**DERBYSHIRE COUNTY COUNCIL**

**MEETING OF CABINET MEMBER – HIGHWAYS, TRANSPORT AND  
INFRASTRUCTURE**

**RESULTS OF CONSULTATION FOR A NEW SHARED USE CYCLE PATH,  
B6057 BETWEEN DRONFIELD AND UNSTONE**

## Unstone to Dronfield Cycle Link - Consultation Drawing

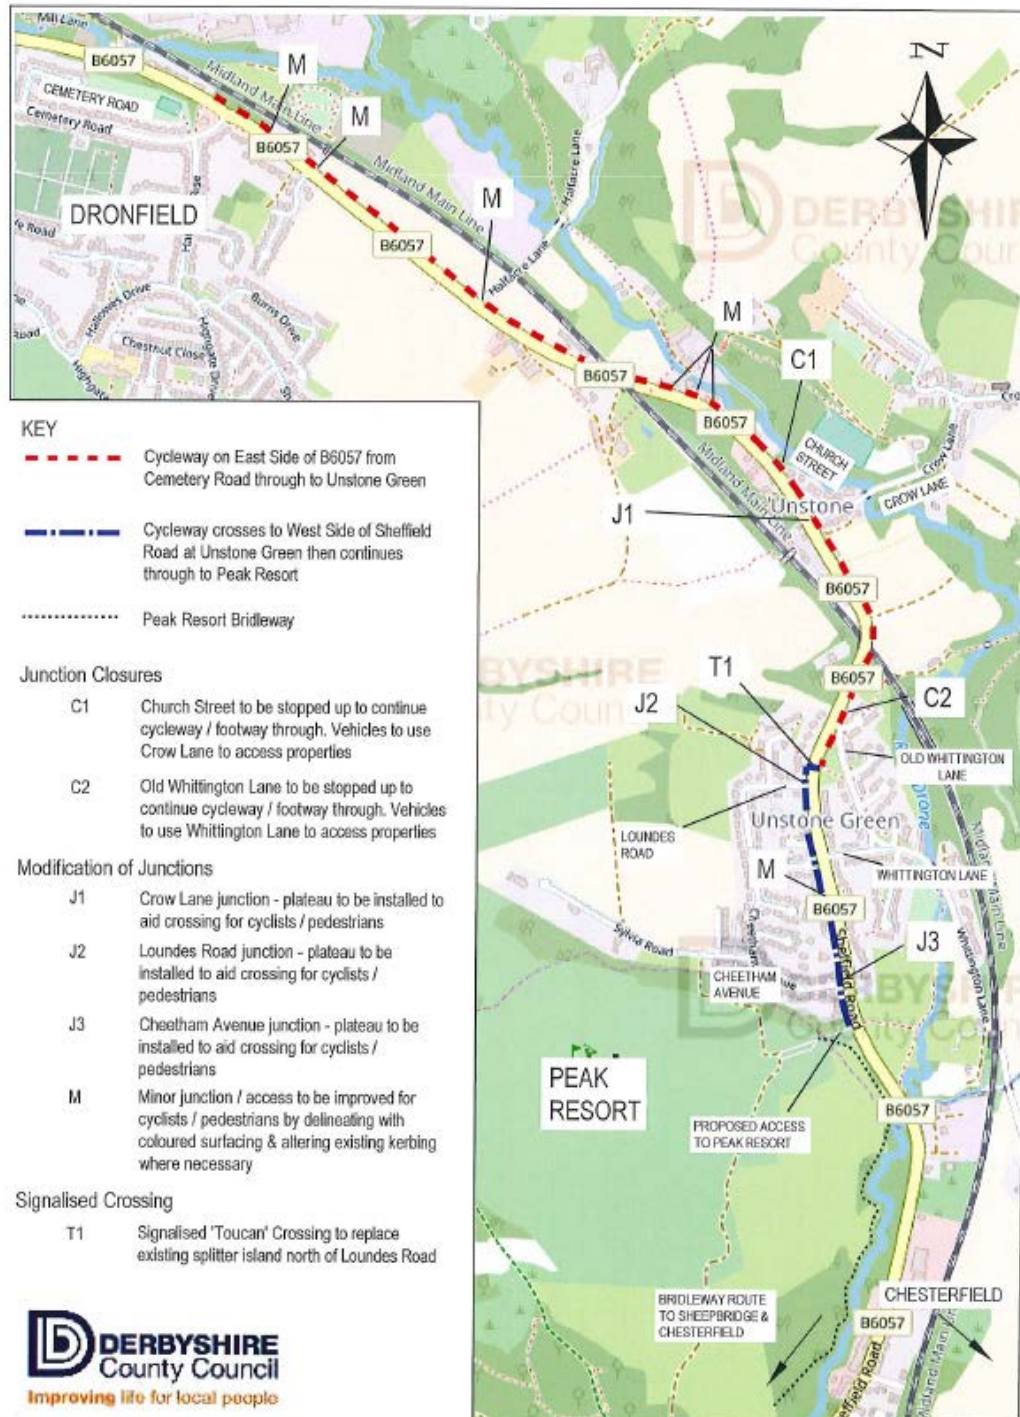
Ref	Respondent Comment	Officer Response
B1	To consider improved visibility for traffic exiting Cheetham Avenue – due to speeding traffic, but also associated with existing narrow footway and boundary wall. Ensure that location of the raised plateau crossing does not interfere with exiting traffic.	Proposals for Cheetham Avenue junction are described in the main report.
B2	Request for a central pedestrian refuge to cross between bus stops near Whittington Lane.	
C2	Narrowing of the carriageway outside the post office means that parking will disrupt traffic flow. Closing Church Street is supported, but as some customers park here, what facilities will be provided to enable people to turn around?	Comments on proposals for Church Street and the Post Office are provided in the report.
C3	Proposal seems to be aimed at commuters and families, has an assessment been done?	Comments on the business case are provided in the report.

C6	Peak Resort bridleways will require a different type of cycle that can be used on the share path. Queried what are the other leisure sites to be accessed?	Peak Resort cycle route surfaces will be constructed to greenway standards and suitable for most cycles. The County Council is working with partners to develop connections to the wider Chesterfield network and destinations such as the TransPennine Trail.
C7	Queried the proposals for the footbridge across the railway and narrow footpath to Old Whittington Lane?	There are no proposals to replace the footbridge as part of this scheme. Therefore, as bridge parapets are sub-standard in highway terms for cycling, signs will be erected at both ends of the bridge to advise cyclists to dismount. Officers have carefully considered the design of the route in these locations and are satisfied that minimum requirements for widening can be achieved, and are in locations with good forward visibility.

C8	Queried the proposals for the narrow footway near Cheetham Avenue and would it affect crossing refuges?	Officers recommend the retention of the traffic island at this location as it is used by local residents to cross to the bus stop and public house. There is no remaining road space to make the western footway wider so this section will be sub-standard. However, there is good forward visibility in both directions over this section to mitigate any conflict between pedestrians and cyclists.
C9	Where is there a safe access into the Peak Resort facility by bike?	Proposals for the entrance to Peak Resort are provided in the main report.

D10	Queried how a sufficiently wide shared facility will be provided under the railway bridge at Unstone Hill?	Comments about route provision on Unstone Hill are provided in the main report. It is recommended that additional signage and “Slow” text and cycle markings are provided in locations where appropriate to advise cyclists to slow down and to take extra caution.
D11	Queried how cycle speeds on Unstone Hill will be managed to avoid conflict with heavy goods vehicles entering/ exiting the works site?	Officers have carefully considered the design of the route in these locations and are satisfied that minimum requirements for widening can be achieved, and are in locations with good forward visibility.
D12	Concerned that traffic congestion and increased air pollution will be caused by stationary buses as a consequence of proposals to remove the southbound bus stop layby near Dronfield.	Public transport officers have advised that the bus stop is not well used and therefore impact on traffic flows likely to be infrequent.

G7	Query about the width of the shared route and visibility of pedestrians and cyclists under the railway bridge where light levels will be lower. Will the road be narrowed or shared route squeezed into pedestrian space?	Comments on route provision on Unstone Hill are provided in the main report.
G8	Query about the status of the shared route over the existing narrow footbridge across the railway line.	There are no proposals to replace the footbridge as part of this scheme. Therefore, as bridge parapets are sub-standard in highway terms for cycling, signs will be erected at both ends of the bridge to advise cyclists to dismount.
G9	Request that trees in the grass verge, south of 'Hallowes' bus stop in Dronfield are protected as they are an asset to the environment.	There are no plans to remove trees within the section indicated by the respondent.
H1	Request consideration to improving visibility of traffic approaching from the left when exiting Cheetham Avenue and to avoid any impact on pedestrian crossings.	Comments on Cheetham Avenue junction are provided in the main report.

Ref	Respondent Comment	Officer Response
C1	Recognise that there is a need for traffic speeds to be reduced (proposed by narrowing the road) and a safer crossing in Unstone provided, the proposals are fraught with outweighing danger issues and the money should be spent elsewhere.	The main report responds to concerns about narrowing the road and safety considerations. The report notes that grant funding cannot be spent elsewhere.
C10	Consider the proposal an ill-thought out plan, would prefer the money to be spent on a new crossing for Unstone village and let commuters who cycle to continue and pedestrians have their pavements back.	The report notes that grant funding cannot be spent elsewhere.
